**Subject:** MHI's Responses to US-APWR DCD RAI No.129-1673 Revision 1

MHI's Responses to US-APWR DCD RAI No.129-1673 Revision 1

**RAI NO.:** NO.129-1673 REVISION 1  
**SRP SECTION:** 04.02 - Fuel System Design  
**APPLICATION SECTION:** 04.02  
**DATE OF RAI ISSUE:** 12/17/2008

Figure 4.02-5-1 Mechanical Properties of the Guide Tube<sup>(1)</sup>

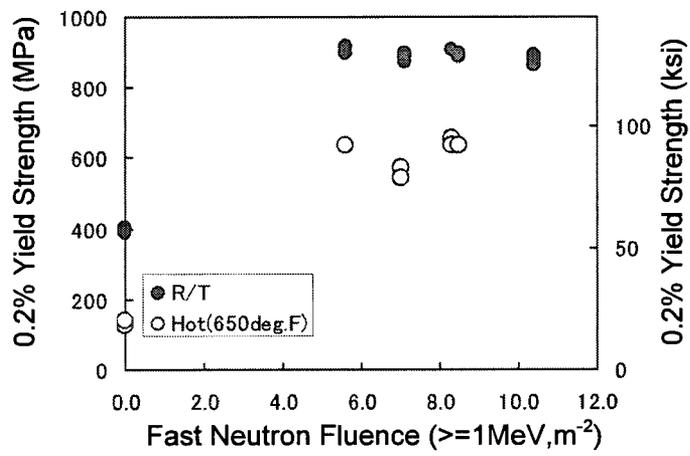
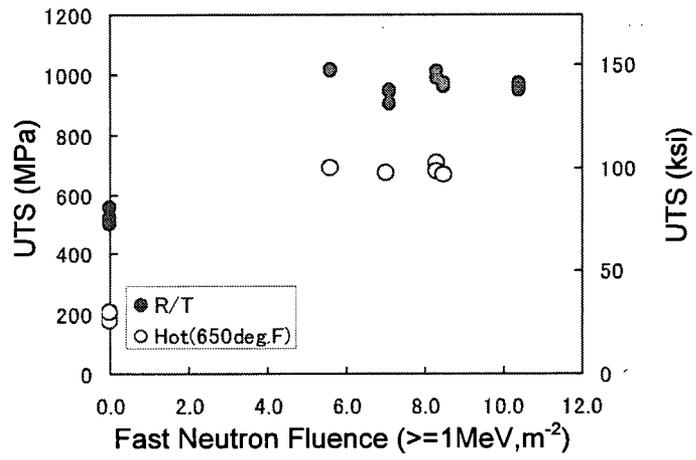
Are guide tube stresses evaluated accounting for oxidation and/or hydrogen pick-up? What oxide thickness and/or hydrogen pick-up values are assumed?

As shown in Figure B.1.2.2-1 of Appendix B of Reference (1), the double sided oxide thickness of the guide tube at assembly burnup of 60 GWd/MTU is conservatively estimated to be less than [ ] mil ([ ]  $\mu\text{m}$ ) which corresponds to [ ] mil ([ ]  $\mu\text{m}$ ) of base material thickness loss. This is approximately [ ]% of the wall thickness of the guide tube. Considering the [ ]% reduction of the guide tube's initial thickness, the stress would increase by [ ]% compared to the beginning of life condition. However, the yield strength and ultimate tensile strength of the guide tubes increase by more than 300 % during irradiation, as shown in Figure 4.02-5-1 (Reference (1) Appendix B Figure B.1.3.6-1). Another benefit is that corrosion is a slow process, with the peak oxide thicknesses occurring at EOL, whereas the material strengthening due to irradiation occurs at relatively low fluence levels. The irradiation-induced increase in the guide tube material strength results in more margin to the allowable stress after the effects of corrosion have been considered.
